MILLSTONE POWER STATION UNIT 3
RESPONSE TO REQUEST FOR ADDITIONAL INFORMATION REGARDING
GENERIC LETTER 2004-02

MPS3 RAI 6

Millstone Power Station Unit 3 (MPS3), Head Loss and Vortexing, RAI 6

Figure 1: Ottawa River Water Level High and Peak MPS3 Rig 33 Test Head Loss

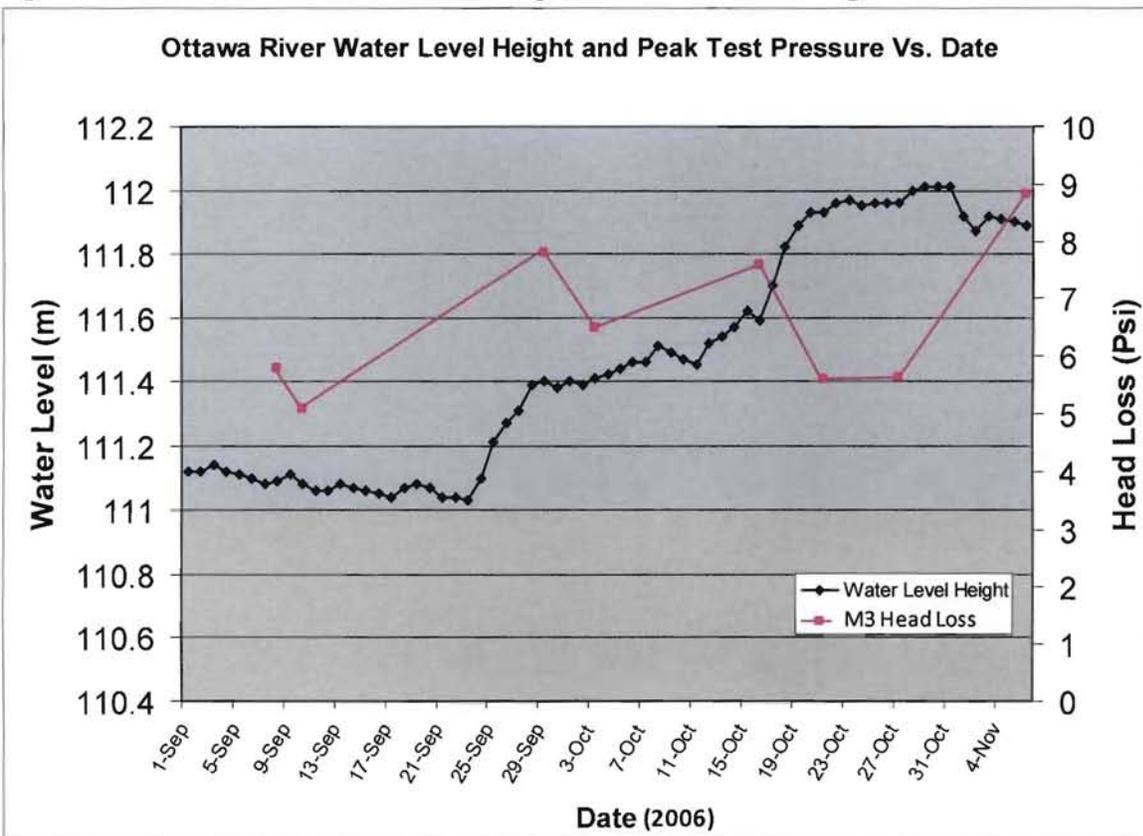
- a. *Provide an evaluation of the degree to which the particulate and biological growth from the river water affected the results of MPS3. It appears that the MPS3 tests were affected to a much greater degree than other AECL tests conducted under similar conditions. Please discuss the reason MPS3 was affected to a greater degree.*

Ottawa River water was used in the Rig 33 tests, while distilled water was used in the Rig-89 test. Bacteria growth and the resulting "biological effects" were observed during Rig 33 testing for Surry in May 2006 [1] and for MPS3 in October 2006 [2]. For the affected tests, biological activity prevented head loss from stabilizing after the second fiber addition. Slime formation was believed to be the major mechanism for biological effects. River water particles also contributed to the higher head loss observed in those tests.

The water level height of the Ottawa River could also affect the concentration of river particles and slime forming organisms. Higher water level resulted in higher peak head loss as shown in Figure 1.

Figure 2: Theoretical Air Evolution at a Point on the Strainer Submerged by 26 Inches

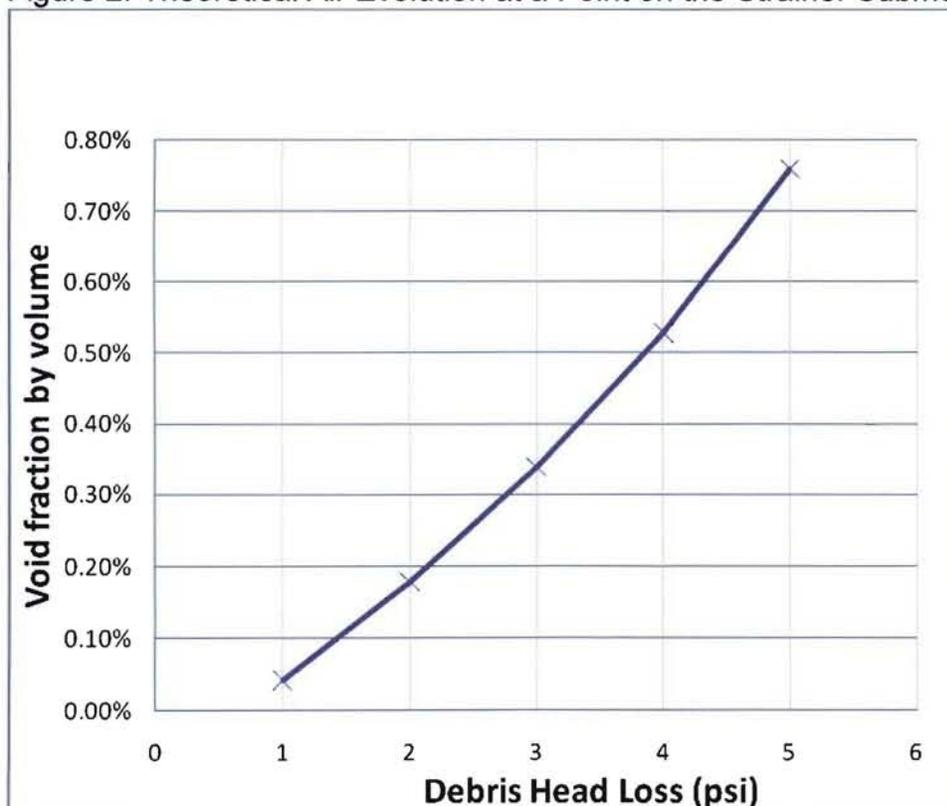
- a. *Please provide an evaluation of how the air evolution phenomenon affected the MPS3 tests compared to other AECL tests conducted under similar conditions. Please provide information on why air evolution, as a factor in head losses, would only occur for AECL strainers.*

Based on a dissolved air calculation, it was found that air evolution increases significantly as the head loss across the debris bed increases. Figure 2 shows a theoretical plot of how air evolution is affected by debris head. This plot assumes that air will immediately evolve out of solution if it exceeds the saturation concentration.

However, it is likely that there is some time delay and the actual air release would be less than indicated. Nevertheless, for a relatively small head loss, air evolution is very low and it starts to become more significant as head loss exceeds approximately 2 psi. The tests performed for other Dominion plants had head losses less than 2 psi, which was not enough to cause significant air evolution.

Figure 4: Air Bubbles Emerging from Discharge Header in MPS3 Large-Scale Test

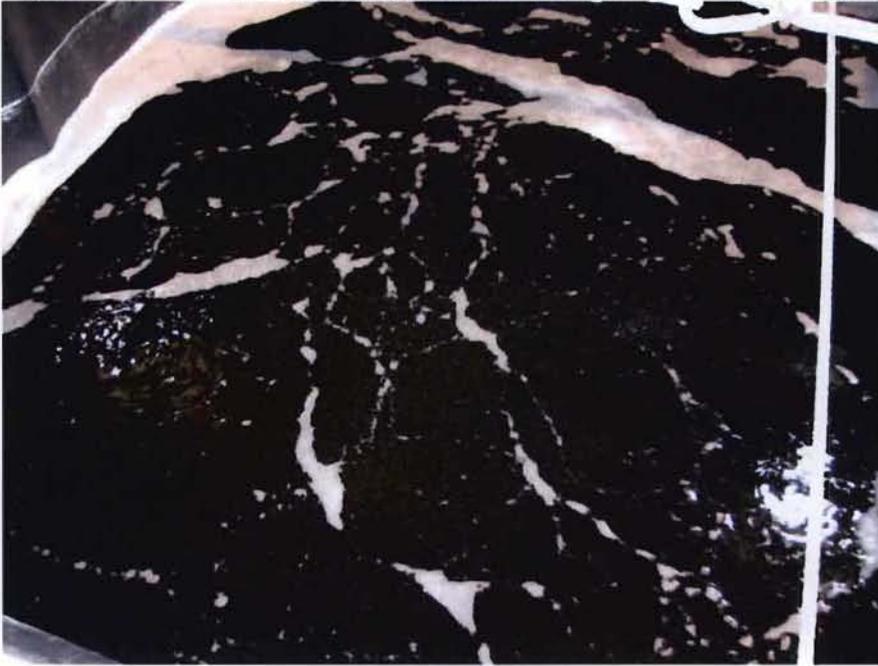
- b. *The response to RAI 4 stated that the air evolution began to affect head loss as soon as the fibrous debris was added to the test and that the head loss began to decrease as soon as fibrous debris additions were stopped. Please provide an evaluation of why the air evolution would begin to affect head loss as fiber was added to the test and why it would stop as soon as fibrous debris additions were stopped.*

The two photos below show air bubbles observed in the MPS3 reduced-scale test (Figure 3) and large-scale test (Figure 4).

The MPS3 large-scale test M3L-2 was performed in the AECL large-scale strainer testing facility—Rig 85. In that test, many air bubbles were observed emerging from the discharge header after the third fiber addition, as shown in Figure 4. The discharge header was located on the floor of the test tank. During the test, the head loss stabilized at 2.7 psi after the second fiber addition. The third fiber addition increased the head loss to 4.1 psi. Three more fiber additions were added into the test and each addition caused

Figure 6: Air Bubbles Attached to Prepared Thermal Wrap Fiber

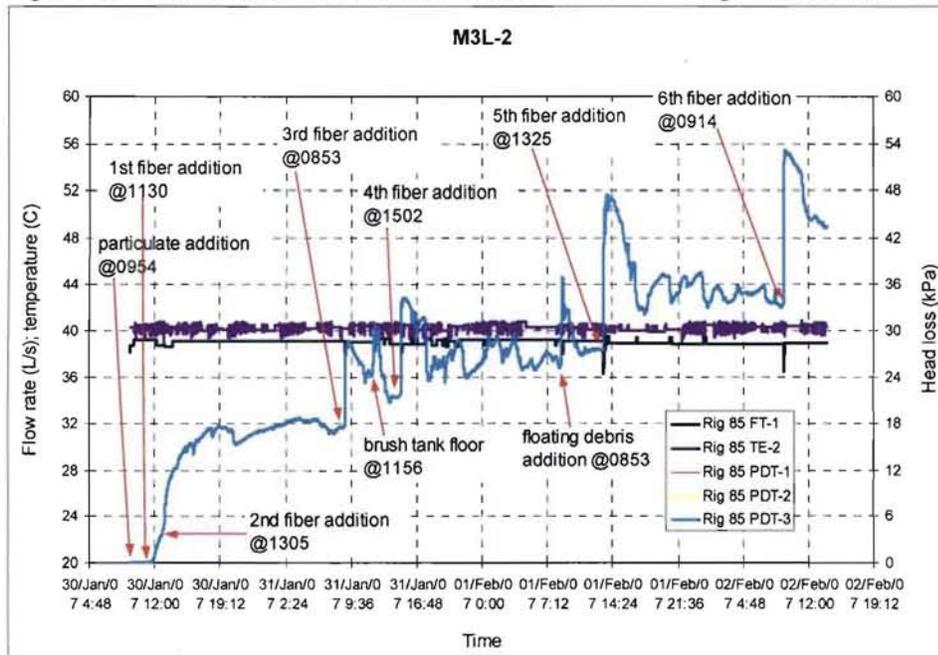
- c. *Please provide an evaluation of why the evolution of air, caused by the addition of fibrous debris with air entrained in it, would result in the highest head loss when a relatively small amount of fibrous debris was added.*

The observed head loss spike after the fourth, fifth and sixth fiber addition was due to the air bubbles trapped inside the fibrous debris. Microscopic examination of fibers prepared in a similar fashion (i.e., using a pressure washer to agitate and break up the clumps of fiber) showed that air bubbles were attached to the fibers (see Figure 6). It was the air bubbles that initiated the pressure spikes, not the fibers.

Figure 9: Debris Bed Thickness after MPS3 Rig 89 Chemical Effects Test

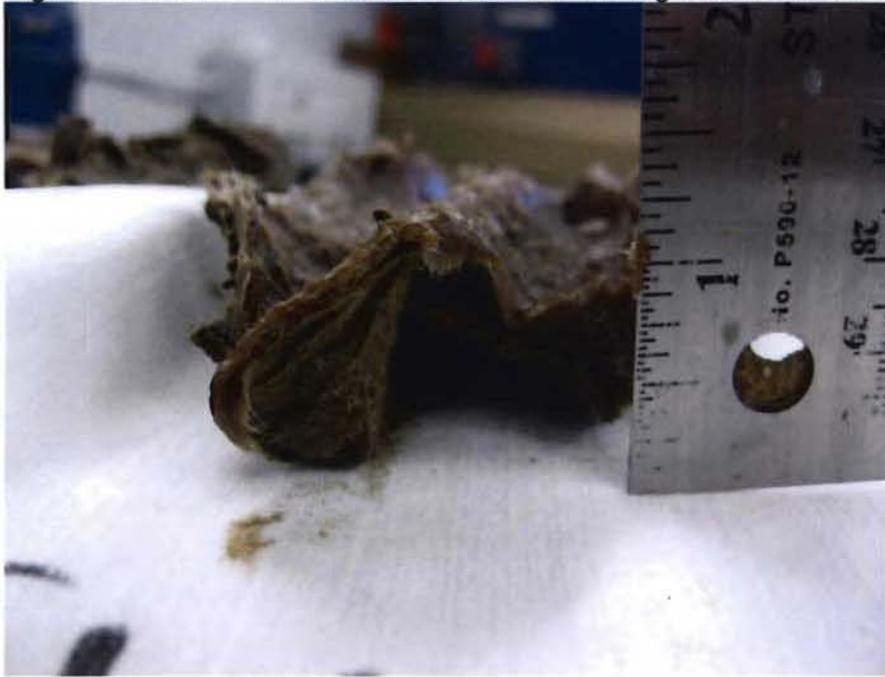
Please provide an evaluation of the potential for the lower head loss in the Rig-89 testing (versus reduced scale testing) to have been caused by agglomeration of debris, especially fibrous debris.

The potential for the lower head loss in the Rig-89 testing to have been caused by agglomeration of fibrous debris was very low. Fibrous debris was sprayed as "single fine" by using a high pressure jet flow in a 200 liter plastic barrel. The sprayed fiber was then added into the in-line debris addition tank. The debris addition tank was equipped with a stirrer. After a batch of fibrous debris was added into the tank, the stirrer was activated to suspend the fiber and to avoid debris settling or agglomeration. The debris addition tank was then valved-in to let the fiber flow to the strainer box slowly by adjustment of the in-line control valves. Figure 7, Figure 8 and Figure 9 show that after the test, the debris bed was firm and uniform. No fibrous debris clumps were observed. The reasons for lower non-chemical head loss in Rig 89 are unclear, however sufficient margin exists as described above, to account for the higher Rig 33 non-chemical head loss results, along with the head loss due to chemical precipitants found in Rig 89.
